System Impact Assessment Report

Addendum Report

CAA ID: 2011-443
Project: Bornish Wind Energy Centre
Applicant: Bornish Wind LP

Date: June 6, 2012

3.3 Revised Facility Single Line Diagram

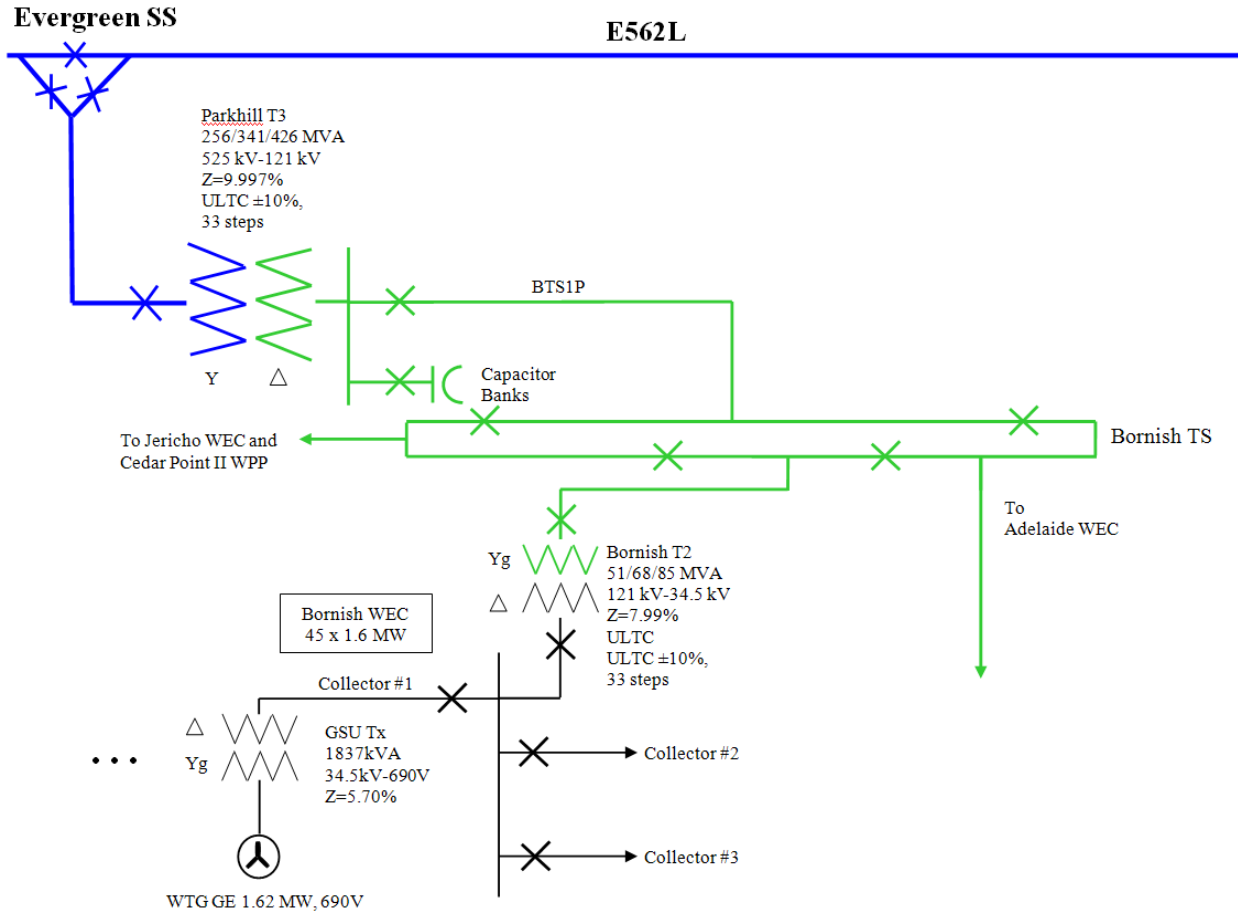
The simulation results indicate that the voltage at Evergreen SS could be as high as 561 kV, thus the IESO accepts the proposed solution to manage the high voltage concern at Evergreen SS. As the reactor is removed, the Evergreen SS arrangement will be modified from a four breaker switching station to a three breaker ring bus switching station, which is acceptable to the IESO.

Based on the incorporation of the Cedar Point II Wind Power Project into the 121 kV network behind Parkhill CTS and the configuration change at Evergreen SS, below is a revised single line diagram for the Bornish WEC.
